AGENDA - LPP

**REPORT TO GEORGES RIVER COUNCIL
LPP MEETING OF THURSDAY, 28 JULY 2022**

LPP032-22

LPP Report No	LPP032-22	Development Application No	MOD2021/0127
Site Address & Ward Locality	3 Cross Street, Kyle Bay Blakehurst Ward		
Proposed Development	Modification of an approved dwelling house		
Owners	A Cristofi and S Harrison		
Applicant	A Cristofi		
Planner/Architect	Avenue Town Planning; David Dechiara		
Date Of Lodgement	9/08/2021		
Submissions	Three for original application		
Cost of Works	\$861,860.00		
Local Planning Panel Criteria	The application is to be determined by the Georges River Local Planning Panel as the application proposes a potential conflict of interest (former Council assessment officer was the engaged planning consultant for the applicant).		
List of all relevant s.4.15 matters (formerly s79C(1)(a))	Environmental Planning and Assessment Act 1979, Environmental Planning and Assessment Regulation 2000, State Environmental Planning Policy (Resilience and Hazards) 2021, State Environmental Planning Policy (Building and Sustainability Index: 2004), State Environmental Planning Policy (Biodiversity and Conservation) 2021, Kogarah Local Environmental Plan 201

Figure 1: Works-As-Executed Plan (Source: Avenue Town Planning, 31/05/2022)

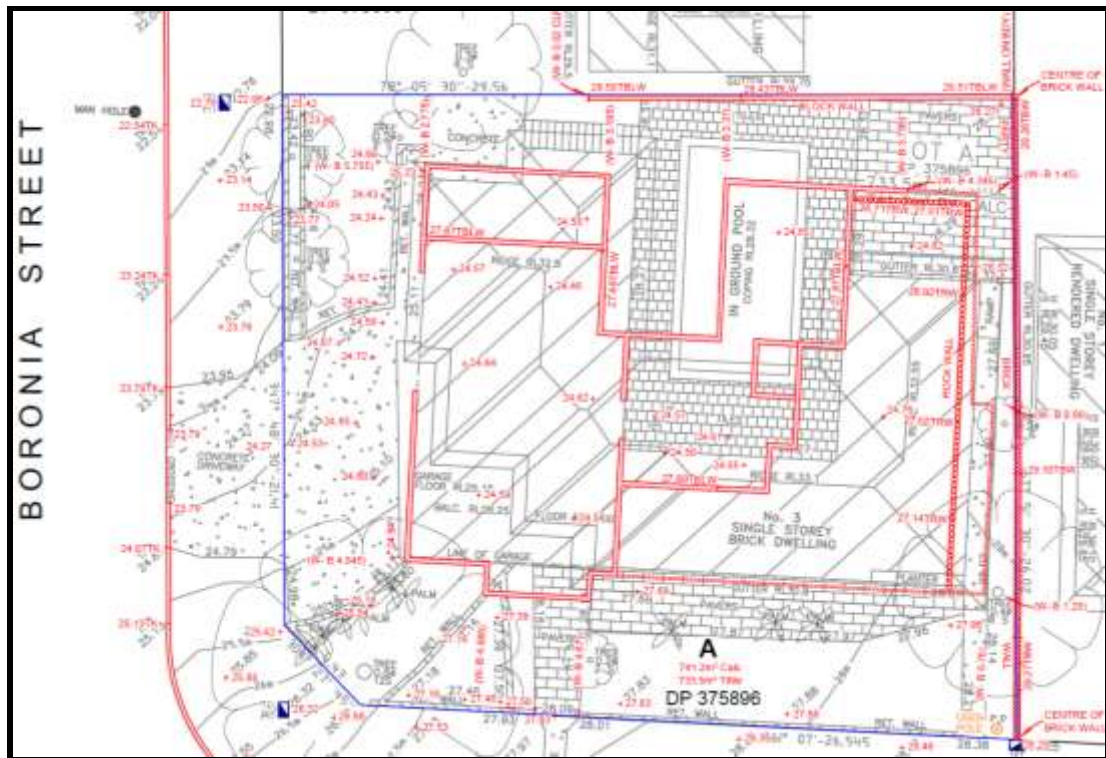
13. Construction of the approved development has commenced on the site and it became apparent at the LPP meeting of 5 May 2022 that the basement walls constructed to date were not all in accordance with the approval. As requested by the LPP, the submitted work-as-executed plan ('WAE Plan') outlines the works which have been undertaken on the site (**Figure 1**) and the revised basement plan (Issue L) outlines the 'walls to be demolished' and 'walls to remain' (**Figure 2**).
14. The existing walls constructed on the site have been grouped into five (5) areas to allow detailed consideration of each of these areas, as outlined in **Figure 3**, and discussed below.

Figure 2: Proposed Basement Plan outlining walls to be demolished and walls to remain (Source: Issue L - David DeChiara, 24/5/2022)

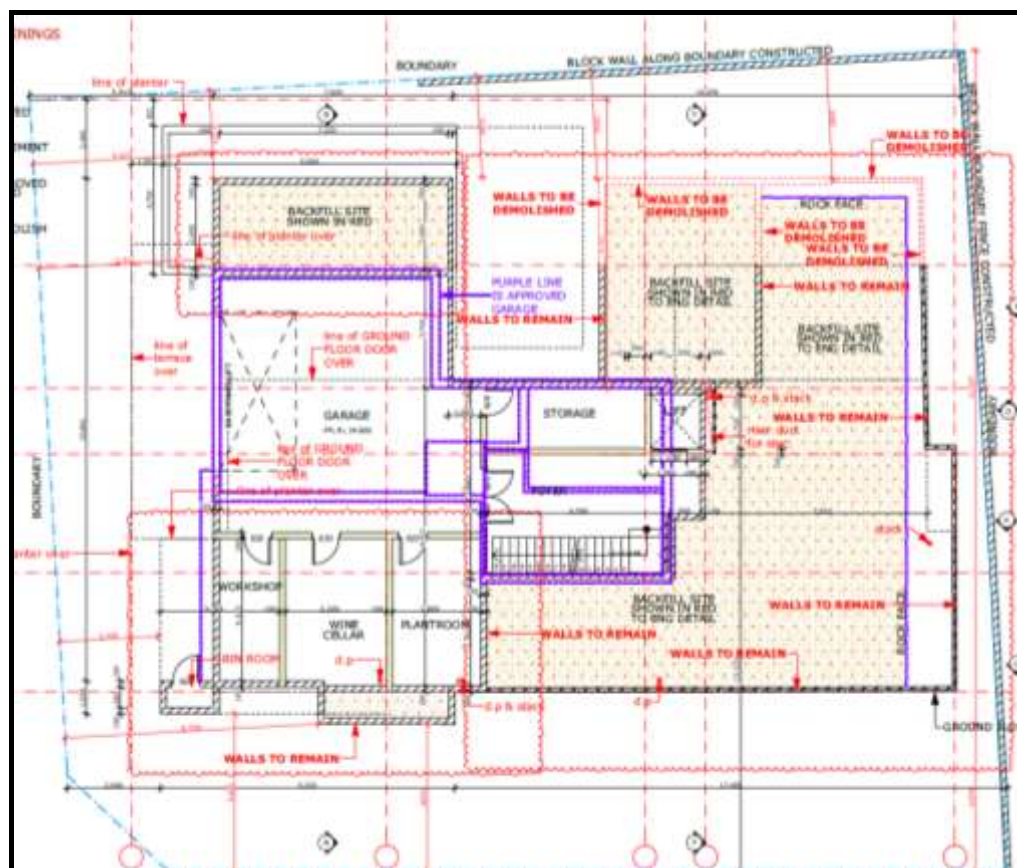
16. Of these four (4) walls constructed in this area, only the southernmost wall is approved, comprising the northern wall of the approved garage. The remaining three (3) outer walls are not approved as they are not included on the approved basement plan (**Figure 5**). The amended basement plan indicates that these walls are to remain.

17. As outlined in this Report, these walls are not supported and should be removed. These constructed walls exacerbate the bulk and scale of the proposed development when view from No 52 Boronia Street and adversely impact on the Boronia Street streetscape. The walls also result in potential visual and acoustic privacy issues for the adjoining property. These walls also facilitate the construction of the higher retaining/planter (inner) wall adjoining the ground floor level as discussed further in this report. The walls also result in significant changes to the natural topography of the site, which naturally slopes down to the common boundary with No 52 Boronia Street.

- Insert a new condition after Condition 13 (as Condition 13A) to require the demolition of the walls marked ‘*walls to be demolished*’ on the amended basement plan (Issue L) and the three (3) constructed basement walls adjoining to the northern side of the garage prior to the issue of an amended Construction Certificate.

Figure 3: Proposed Basement Plan outlining walls to be demolished and walls to remain (Source: Issue L - David DeChiara, 24/5/2022)

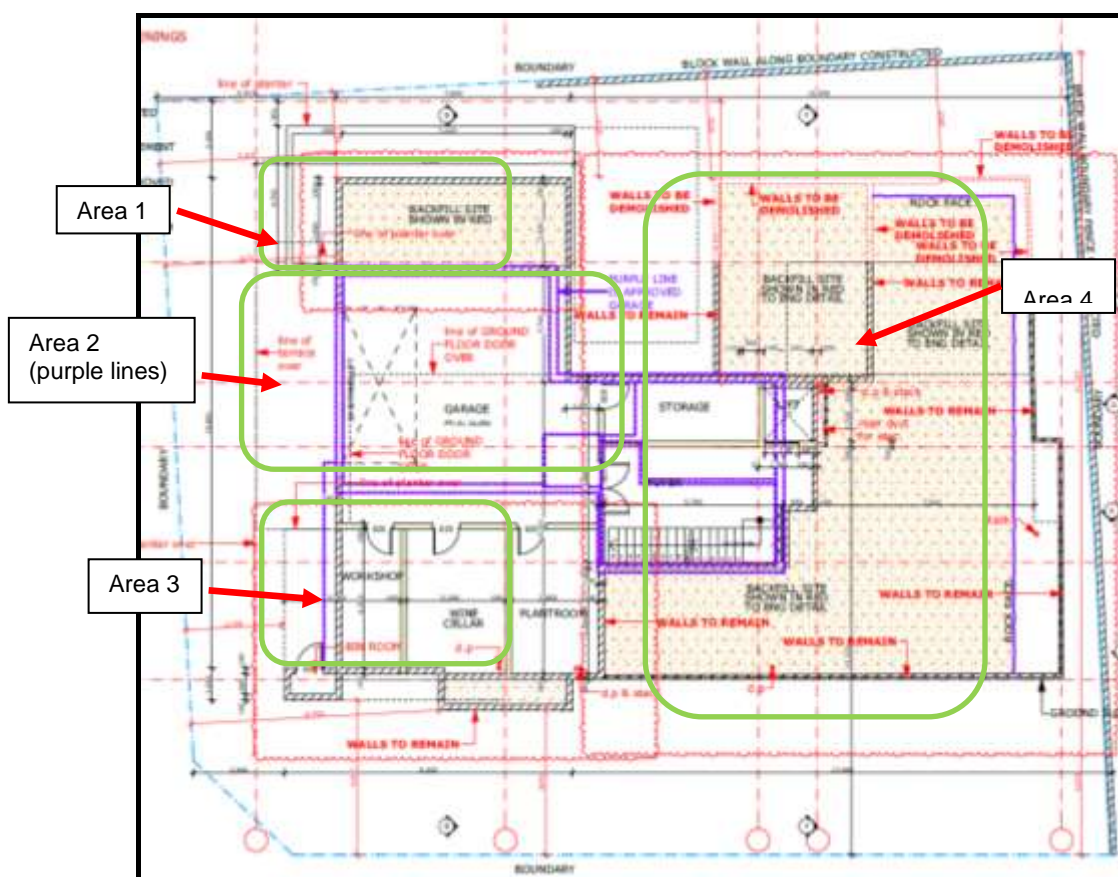
24. The ends of these walls are proposed to be demolished on the amended basement plan. This is supported as it will allow this NE corner to be landscaped area. This will require significant backfilling as the level is currently approximately RL 24.850m (basement floor level) and is proposed to be at RL 27.95, which is more closely aligned with level of the ground floor of the dwelling (RL 28) (**Figure 9**).

Figure 5: Approved Basement Plan (Source: *Council file*)

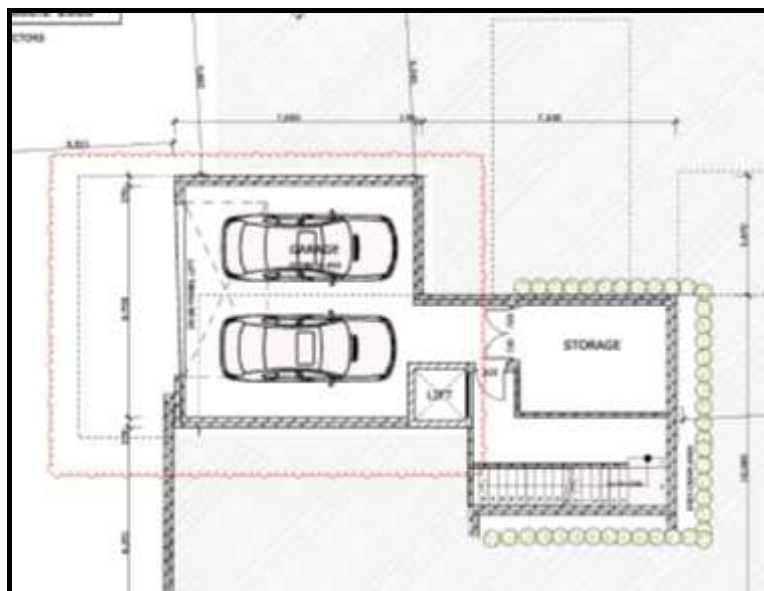
19. This area comprises the walls in purple which consist of the approved basement walls, which are to be retained. Comparing this wall configuration with the approved basement plan (see Figure 5), this is a generally consistent representation of the approved basement walls (illustrated in Figure 4).

20. There is a minor change in the alignment of the eastern side wall of the garage, which would appear to have been constructed approximately 190mm towards the east, however, this is unlikely to result in any impact to the overall design or the amenity of adjoining properties given it is located internally within the site. The retention of these walls is supported and no further condition changes are necessary.

Figure 10: Approved Basement Plan showing outline of the ground floor above (Source: Council file)

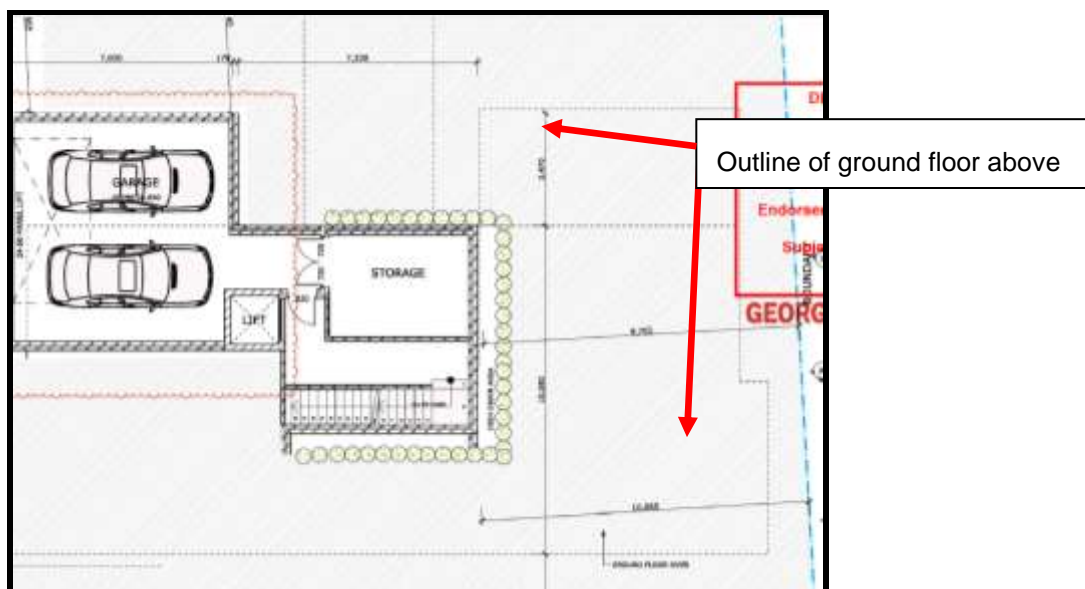
25. The retention of the other portions of these walls is satisfactory as these walls are required for structural support to the ground level of the dwelling above given the extent of excavation which has been undertaken on the site. The outline of the ground floor level as shown on the approved basement plan generally follows these wall alignments with the northern extent of these walls assisting with structural support to the alfresco area above (**Figure 10**).

Figure 12: Approved site plan - DA 2020/0145 (Source: Council file)

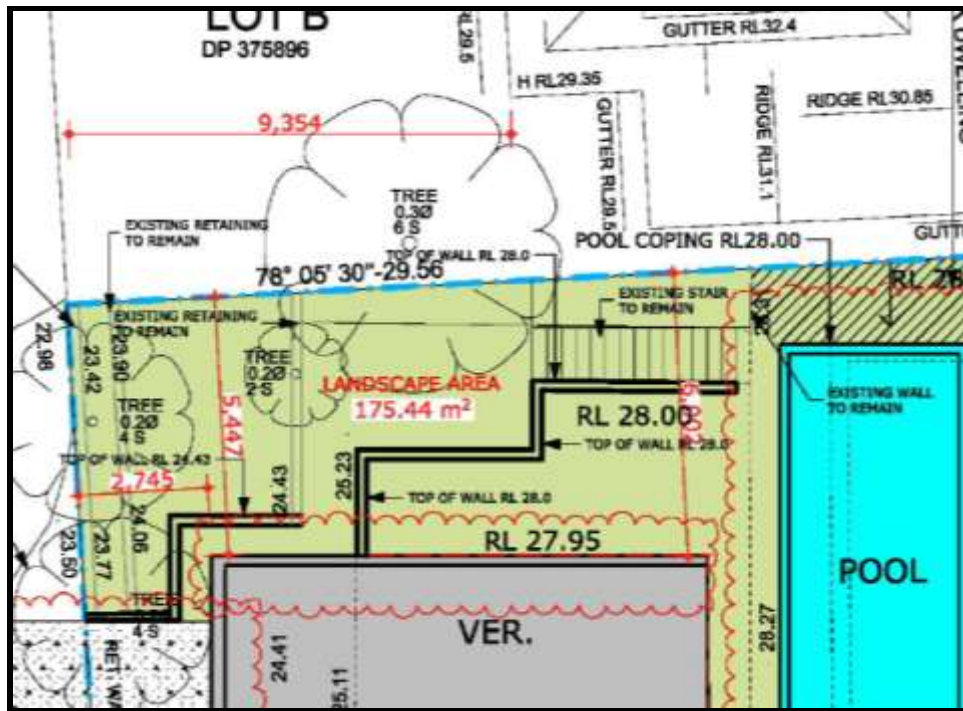
33. The approved layout of walls in this portion of the site comprises a staggered retaining wall with a top of wall height of RL 28.0, which is consistent with the level of the ground floor of the approved new dwelling. The area between this approved retaining wall and the northern edge of the approved verandah adjoining the ground floor of the dwelling is approved as a grassed area and forms part of the landscaped area on the site.

34. An additional smaller, staggered retaining wall was also approved to the north-west of this larger wall and closer to the Boronia Street boundary, with the top of the wall at RL 24.43, approximately 3.57 metres lower than the larger wall (**Figure 12**). This smaller wall comprised a length of approximately 2.3 metres to the Boronia Street boundary and comprised a height of approximately 450mm. This approved wall was only shown on the approved site plan and did not appear on any of the floor plans or elevations.

35. This arrangement allows for a stepped wall configuration to the side boundary with landscaping along the fence line, and minimal changes to the site topography, allowing the site to naturally fall to the boundary with No 52 Boronia Street.

Figure 14: Proposed Retaining Walls in NW corner (Source: Issue L - David DeChiara, 24/5/2022)

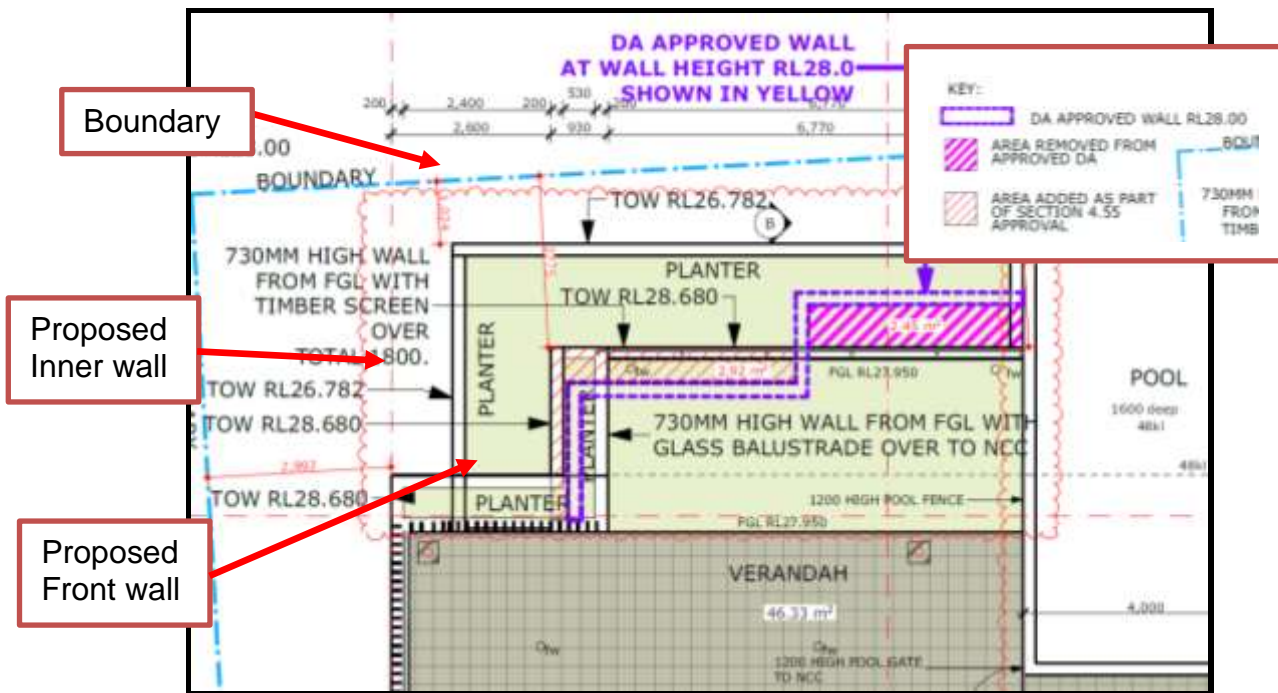
38. The proposed modification seeks to change these approved staggered retaining walls by proposing two (2) longer and higher retaining walls comprising the following walls (refer to **Figure 14**):

- (b) An inner wall with a height of a minimum of 3.83 metres at RL 28.680 when viewed from Boronia Street (to RL 24.850 – garage level). This is 680mm higher than approved wall. This larger/higher wall is proposed to be 2.797 metres from the northern side boundary at its closest point.

39. The purple line in Figure 14 above denotes the approved retaining wall. As outlined, there is a small area to be removed at the higher level and an additional area created as a result of the proposed altered layout of the retaining walls in this area of the site.

49. Accordingly, it is considered that the proposed new retaining walls cannot be supported and an amended design change condition is necessary (to existing Condition 13) to remove the retaining/planter walls in the north-western corner of the site. This will ensure the walls approved in DA 2020/0145 are retained.

Figure 15: View of Proposed retaining walls from Boronia Street frontage (Source: Source: Issue L - David DeChiara, 24/5/2022)

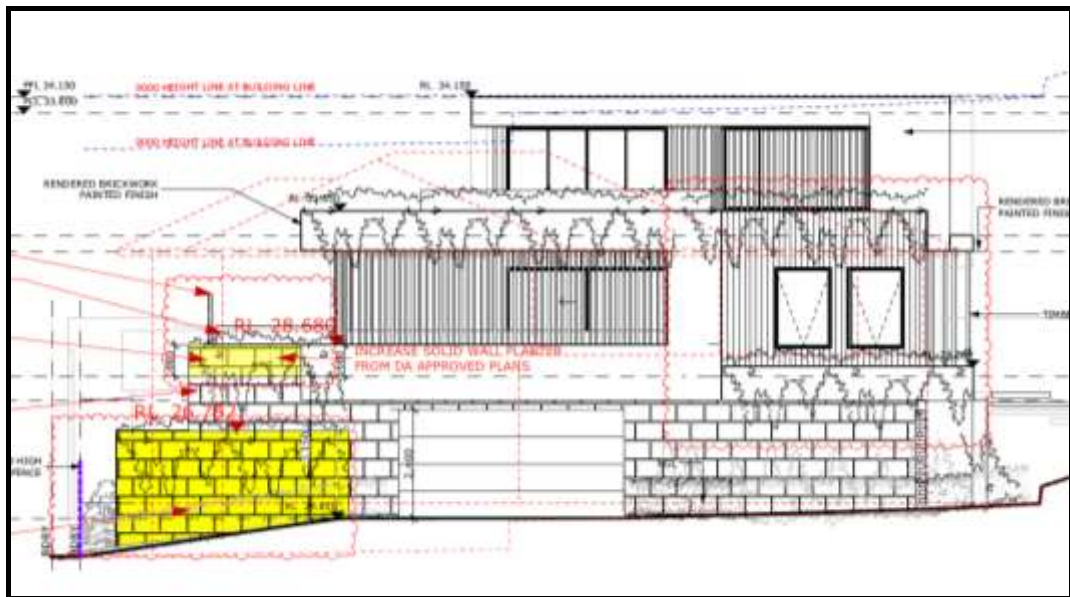
41. The combined effect of these two proposed walls is that a 3.83 metre high wall addresses the Boronia Street frontage. These walls when viewed from Boronia Street is illustrated in **Figure 15**.

42. These proposed walls significantly add to the bulk and scale of the overall development when viewed from Boronia Street, which already consists of a number of block walls in the south-western corner, near the intersection with Cross Street for the extended basement. The retention of the natural sloping topography and a reduction in built form elements such as walls is required in this north-western corner to more appropriately balance the built form on the site. This would also provide greater landscaping opportunities, particularly within the front setback area to soften the building behind.

Figure 16: Proposed Retaining wall – Northern elevation (Source: Issue L - David DeChiara, 24/5/2022)

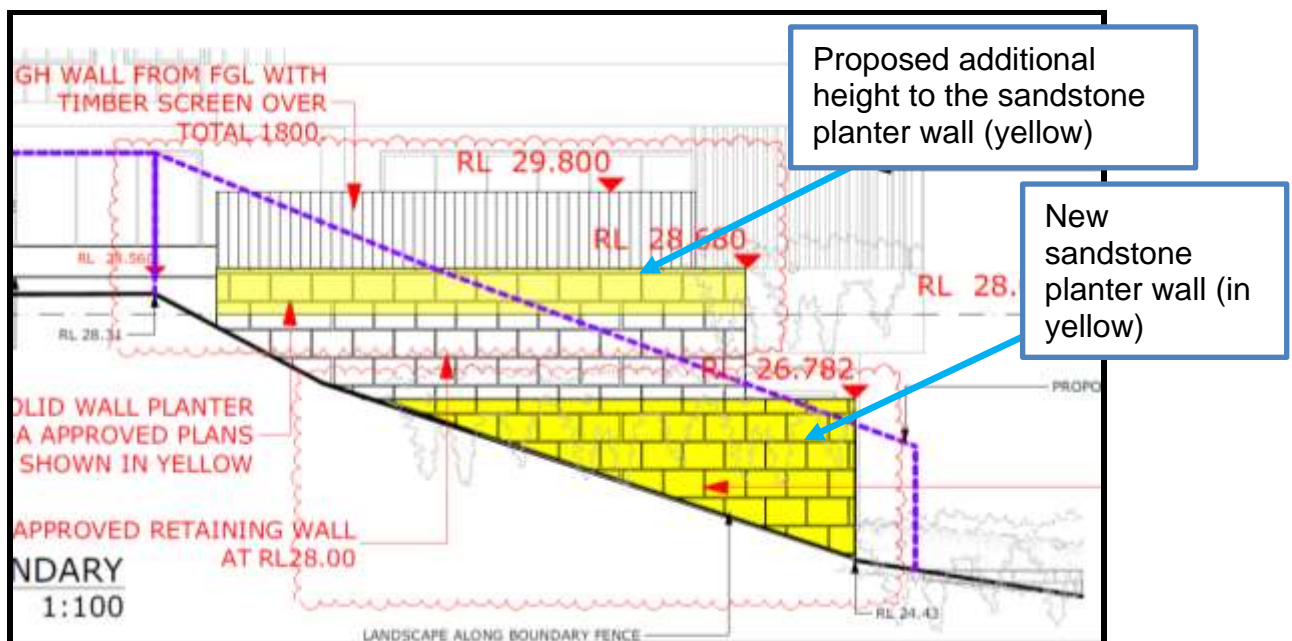
43. The cumulative impact of the proposed retaining walls and the relocated privacy screen in this north-western corner of the site when viewed from the adjoining northern property, is illustrated in **Figure 16**. The dashed purple line indicates a 1.8 metre high boundary fence which gives a perspective on the scale of the proposed walls, with the yellow shading indicating the proposed new walls.

Figure 19: Proposed retaining walls and privacy screen (Source: Issue L plans – David Dechiara, 24/5/22)

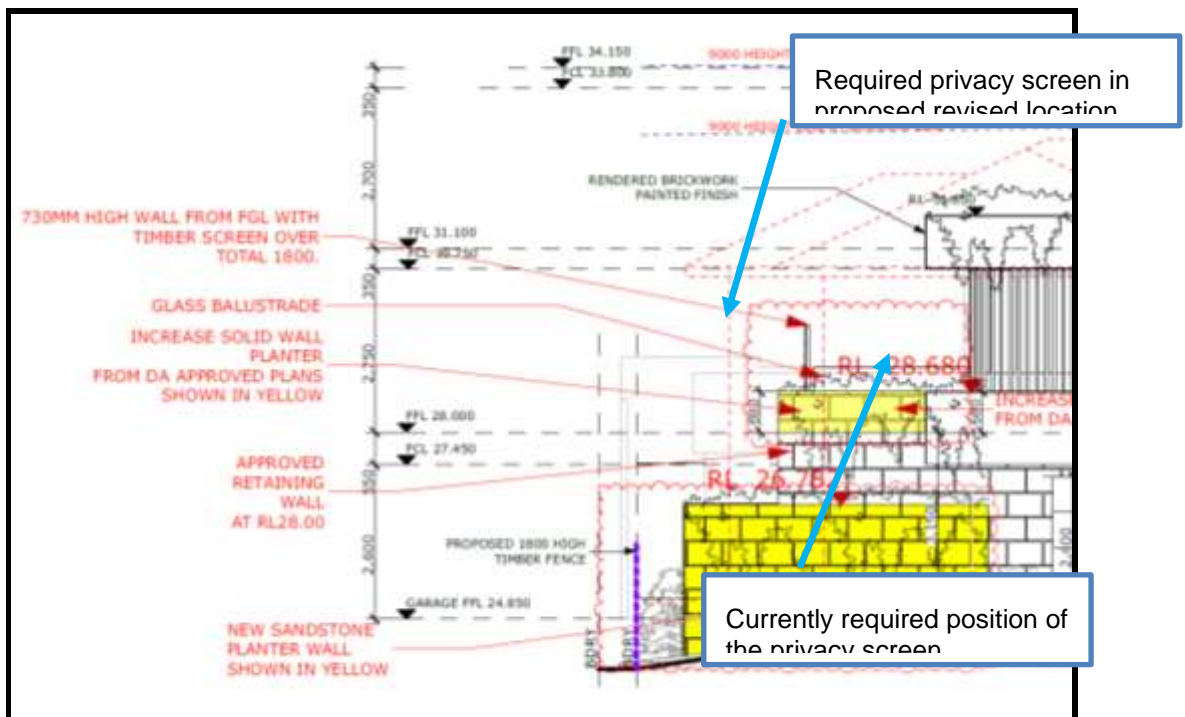
54. The privacy structure is proposed to comprise a 730mm high wall with a timber screen over with a total height of 1.8 metres on top of the proposed retaining wall (RL 28), which would result in a structure which is at RL 29.80 (RL 28 plus 1.8m) (**Figure 19**).

55. It is presumed that the effect of this proposed change is to increase the level outdoor space adjoining the pool and the verandah which would not be confined by the required privacy screen. This enlarges an outdoor private open space area in close proximity to the adjoining property at No 52 Boronia Street, which is likely to result in adverse acoustic privacy impacts to No 52 as well as adverse visual impacts on the adjoining dwelling arising from such a change.

56. The requirement for the louvered privacy screen to be erected along the northern edge of the elevated ground floor verandah allows the bulk and scale of the screening to be offset from the boundary and increases the distance from the boundary for outdoor open space which will reduce the acoustic impacts to the adjoining property. Accordingly, the relocation of the required privacy screen is not supported.
